PROJECT COMMENTS

SP2023-004 Amended Site Plan for a Car Wash 2525 HORIZON RD CASE MANAGER: CASE MANAGER PHONE: CASE MANAGER EMAIL: Bethany Ross (972) 772-6488 bross@rockwall.com

PLANNING AND ZONING COMMISSION CASE MEMO

TO:	Planning and Zoning Commission
DATE:	February 14, 2023
APPLICANT:	Ibrahim Kassem
CASE NUMBER:	SP2023-004; Amended Site Plan for a Car Wash

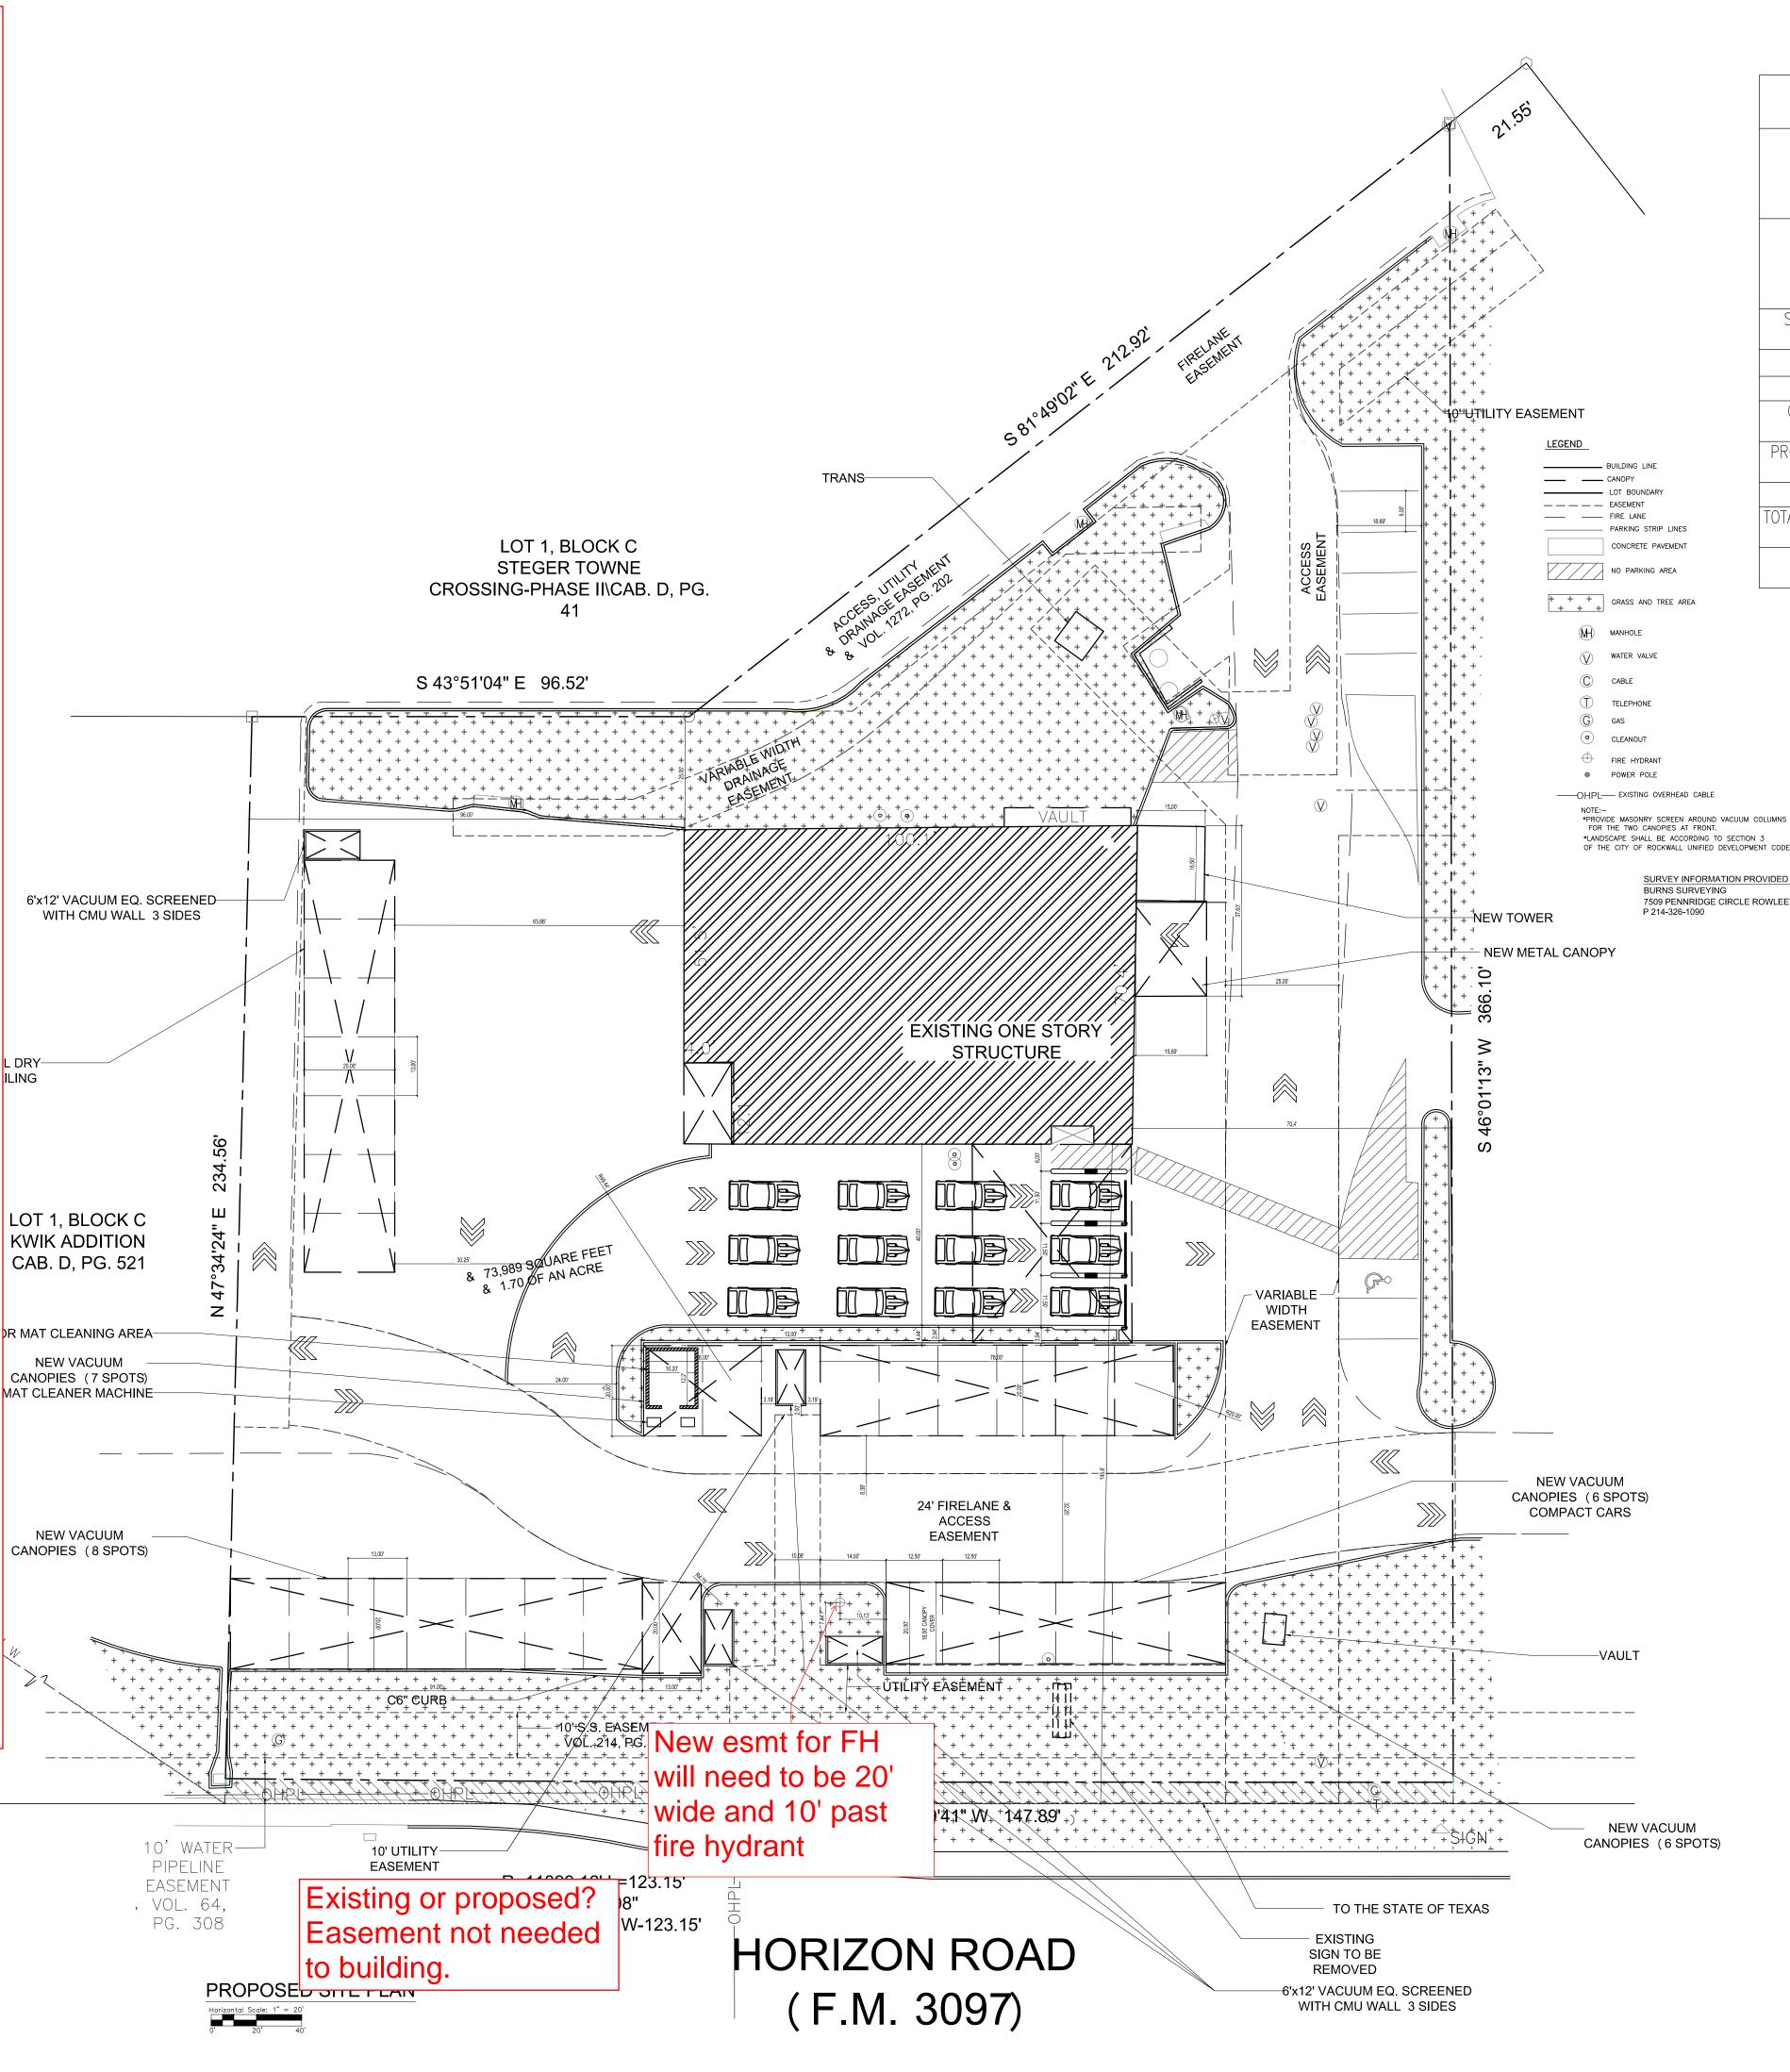
01/26/2023: - New esmt for FH will need to be 20' wide and 10' past fire hydrant.

- Existing or proposed? Easement not needed to building.

01 SITE PHOTOMETRIC PLAN SCALE : 1/2"-1'-0"

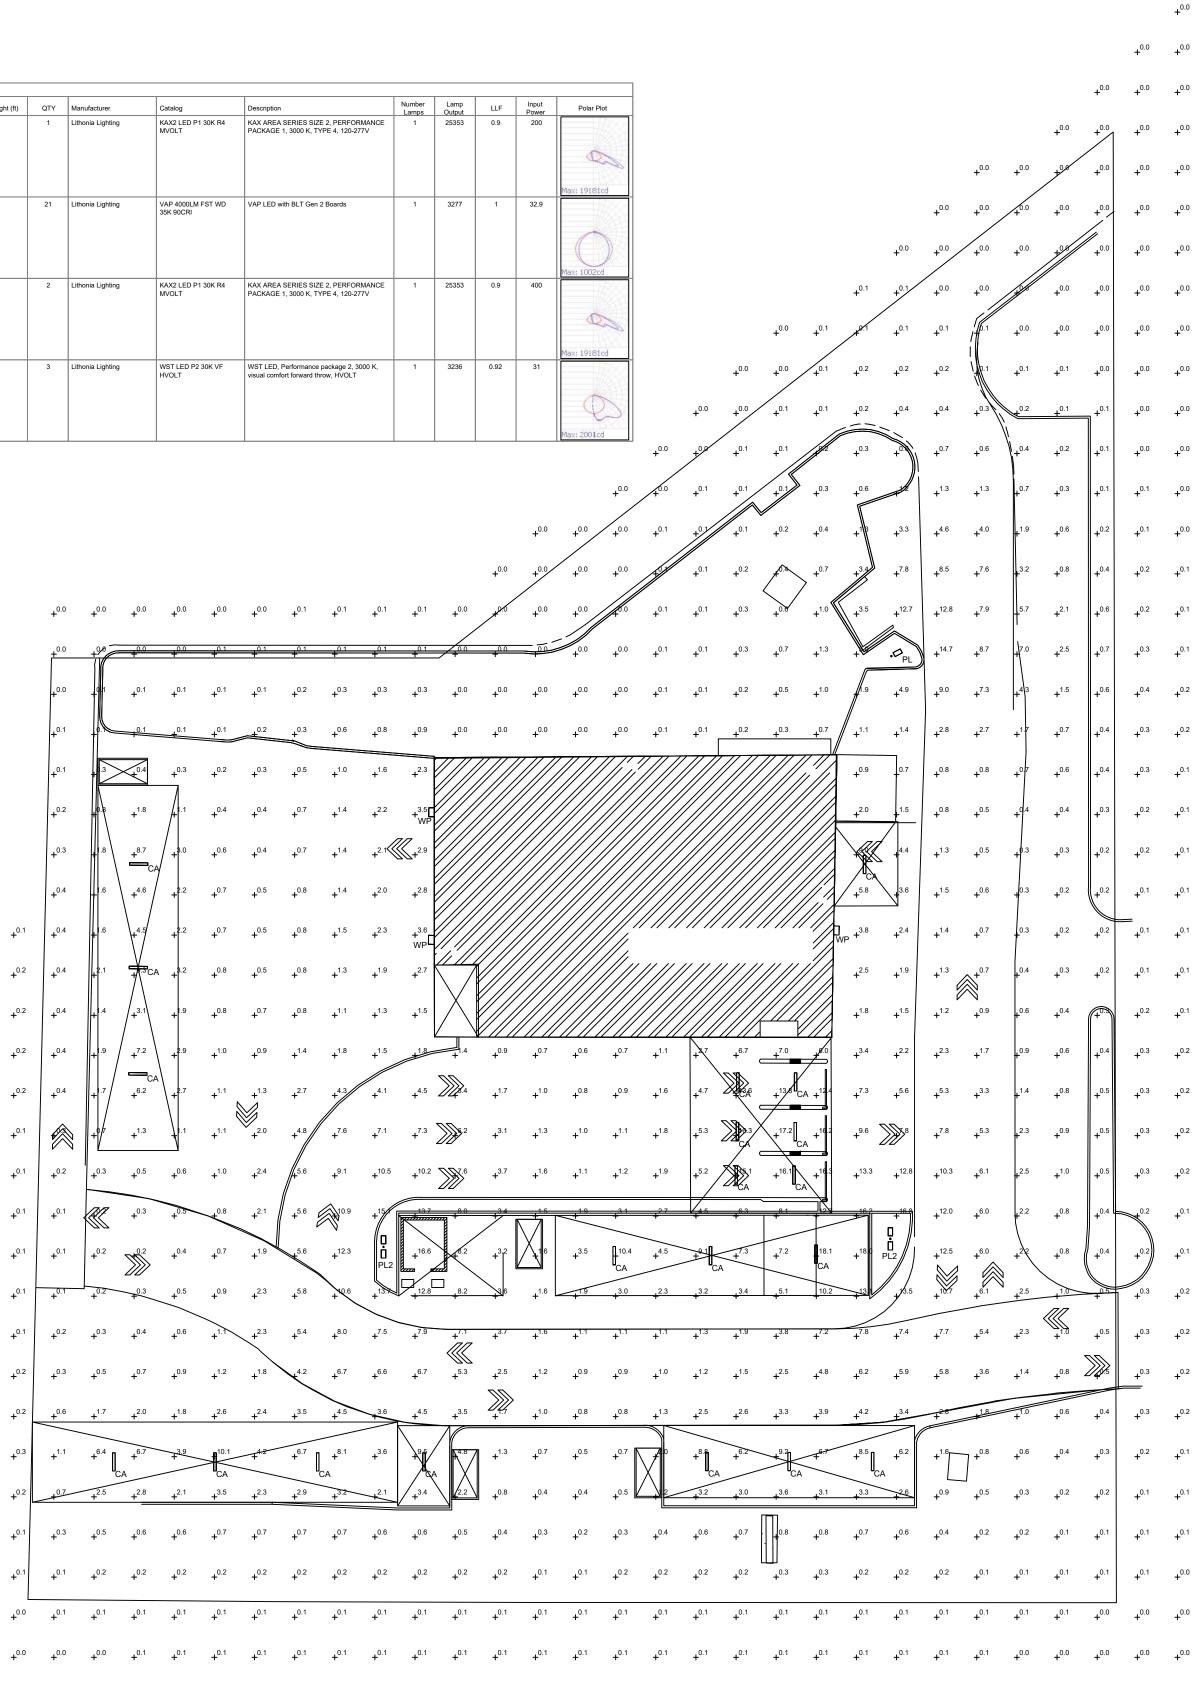
- (1) All staff comments provided by the Planning, Engineering and Fire Department must be addressed prior to the submittal of a building permit.
- (2) The applicant shall provide an updated photometric plan and lighting cut sheets that conform to the requirements set forth by the Unified Development Code (UDC) prior to the issuance of a building permit.
- (3) Any construction resulting from the approval of this <u>Amended Site Plan</u> shall conform to the requirements set forth by the Unified Development Code (UDC), the International Building Code (IBC), the Rockwall Municipal Code of Ordinances, city adopted engineering and fire codes and with all other applicable regulatory requirements administered and/or enforced by the state and federal government.
